TOWN OF PUTNAM

Inland Wetland Commission Special Meeting
Hybrid Meeting
December 29, 2022 6:00 P.M.
Municipal Complex Room 109 First Floor

Continue Public Hearing on Application 2022—09 Putnam River Road, LLC & 285 River Road, LLC request for an 11 lot Subdivision and Gravel Excavation for properties located at 357 River Road, Town Assessors Map 043, Lot 010, Zoned Agricultural-2 and 285 River Road, Town Assessors Map 043 Lot 005, Zoned Agricultural-2. Development will include the excavation of gravel to create two permanent ponds. VOTE REQUIRED

**RE: 285 River Road & 357 River Road – Proposed 11 Lot Resubdivision – Putnam, CT
P&R Job No. 203095**

DATE: 6/29/2022	DRAWN: DJH
SCALE: AS SHOWN	DESIGN: DJH
SHEET: 17 OF 17	CHK BY: ----
DWG. No: Client File	JOB No: 203095

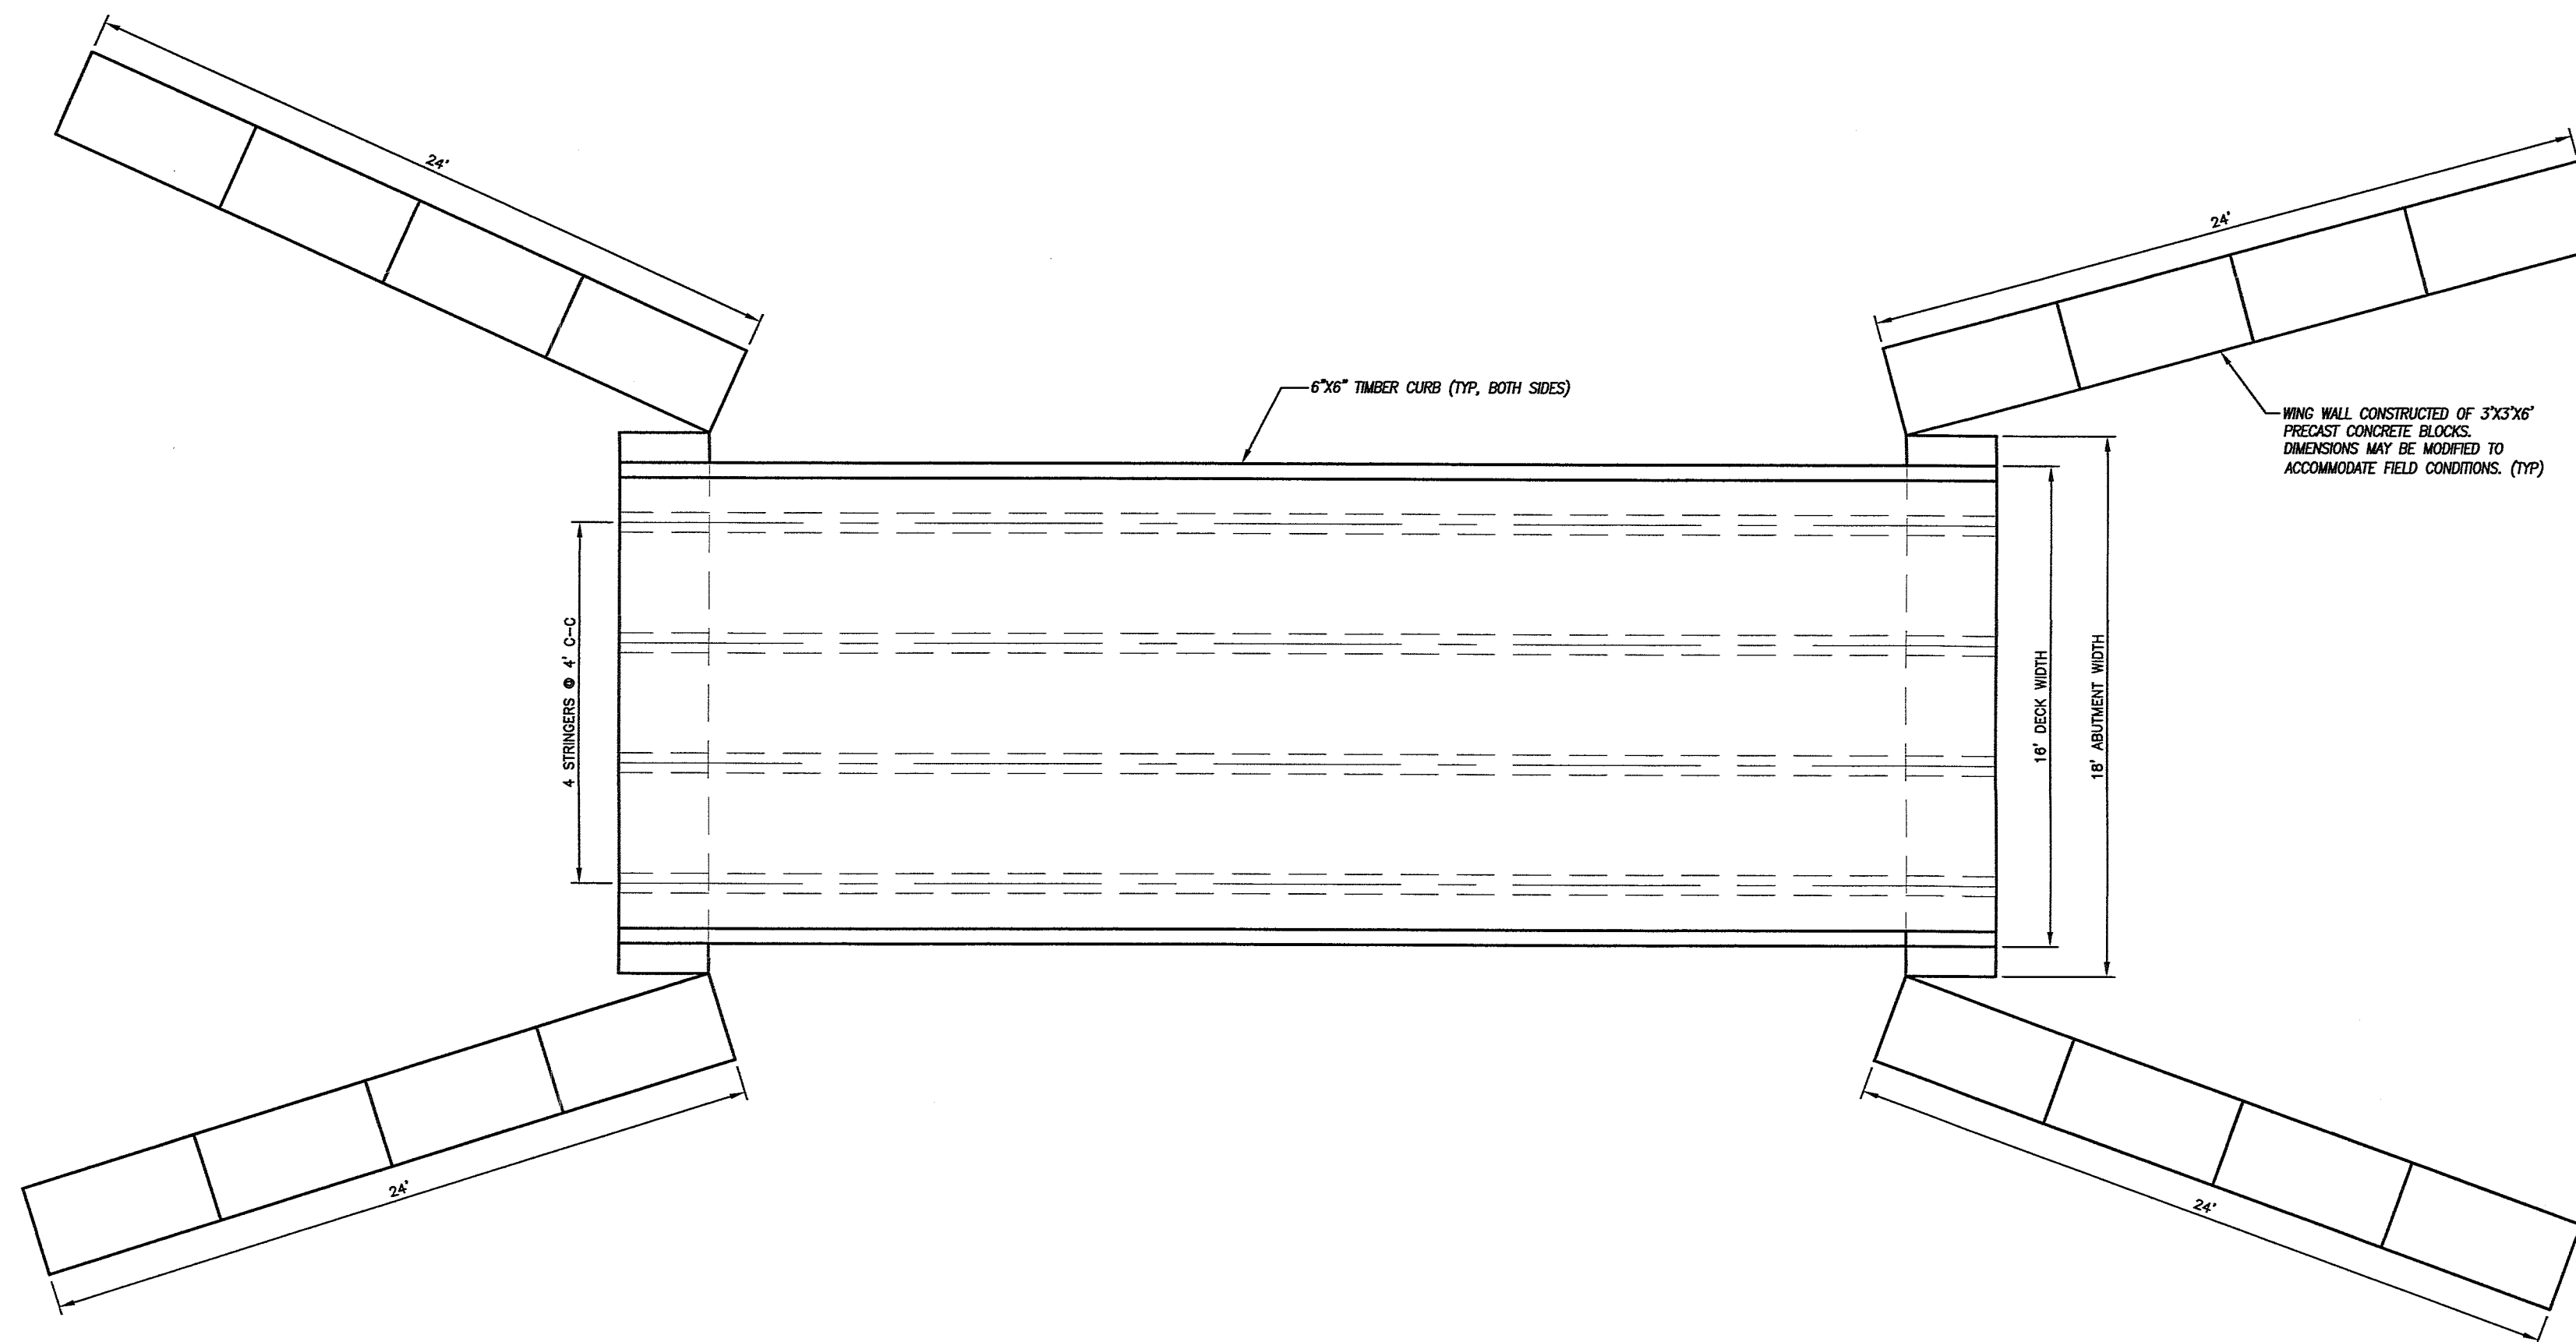
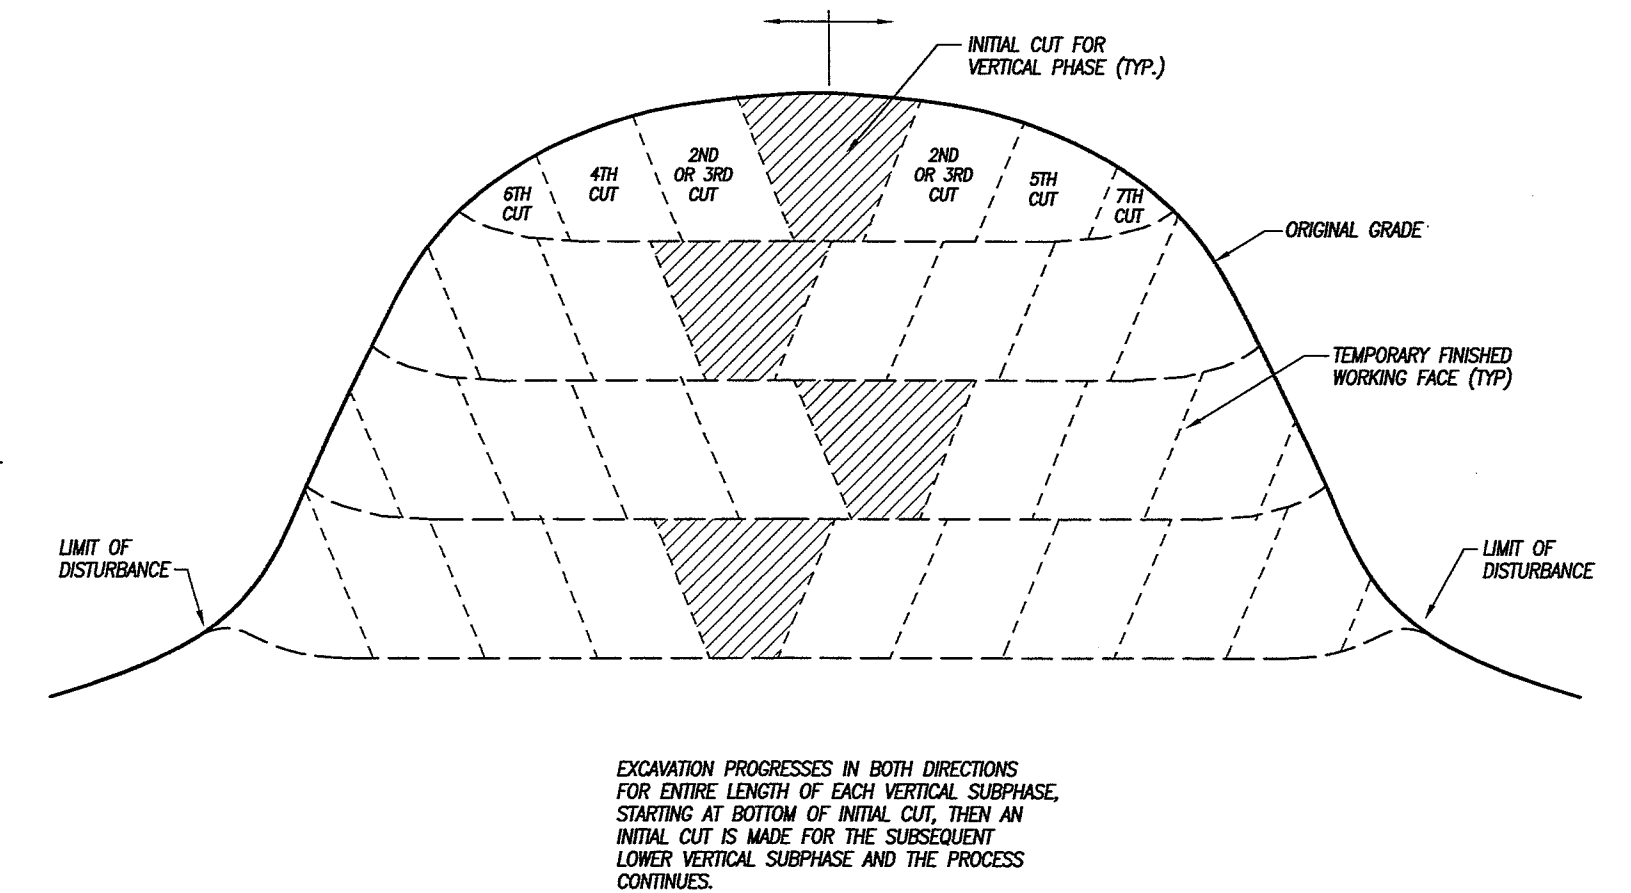
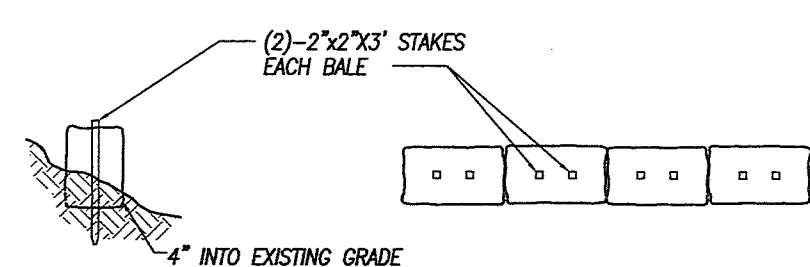
2. Specific bridge construction and removal notes have been added to sheet 17 requiring the completion of construction and removal without equipment operations or other direct impacts within wetlands. Stabilization and restoration requirements following removal are also specified.

3. The proposed bridge span has been increased by 10’ to provide 40’ between abutment faces. This will provide additional construction space without potential intrusion into the wetlands. The increased span will also minimize the necessary excavation and filling for installation of the abutment blocks.

4. The longitudinal bridge section and construction and removal notes specify staked straw wattles for temporary erosion and sedimentation control during construction. Inspection opportunities and requirements for the town’s wetlands agent have also been included.

1. The bridge shall be installed without operating equipment within wetlands or watercourses. Temporary access to the construction area shall be provided through Lots 6 and 7 if necessary to accomplish the bridge construction.

2. The bridge shall be installed during a period of low flow in Carpenter Brook.
3. All materials necessary for construction of the bridge abutments shall be staged on site to allow for expeditious completion of abutments.

4. Prior to starting bridge construction, the contractor shall verify that whether forecasts do not anticipate significant precipitation events for a one week period to allow for substantial completion of the bridge prior to a significant precipitation event.

5. Staked straw wattles shall be installed at the limits of disturbance prior to any ground disturbance. The Putnam Wetlands Agent shall be notified when wattles have been installed and shall be given 24 hours for inspection of the installation prior to any additional work on the bridge. Wattles shall be maintained until disturbed areas are stabilized with vegetation.

6. Immediately after installation of abutment blocks, all disturbed areas shall be stabilized with loam, seed, mulch and temporary erosion control blankets.

At the completion of restoration operations in the Phase 1 excavation area and cutting back from the Putnam Wetlands Agent shall be notified that no additional work is required, the bridge shall be removed. Removal work should be done during a period of low flow in Carpenter Brook. Removal work shall also be coordinated with returning seeding dates to allow for rapid establishment of permanent vegetation following seedling establishment.

8. Prior to the start of bridge removal work, staked straw wattles shall be installed at the limits of anticipated ground disturbance. Wattles shall be maintained until all disturbed areas are permanently stabilized with vegetation. The Putnam Wetlands Agent shall be notified when wattles have been installed and shall be given 24 hours for inspection of the installation prior to any additional removal work.

9. No equipment shall be operated within wetlands or watercourses for removal of the bridge.
10. After abutment blocks have been removed, the resulting voids shall be backfilled with compacted clean fill and all disturbed areas shall be stabilized with 6" of topsoil, seed and mulch. Seed Rate: 100 lbs/acre of Certified Seed mix requirements. Seeded areas shall be protected with temporary erosion control blankets.
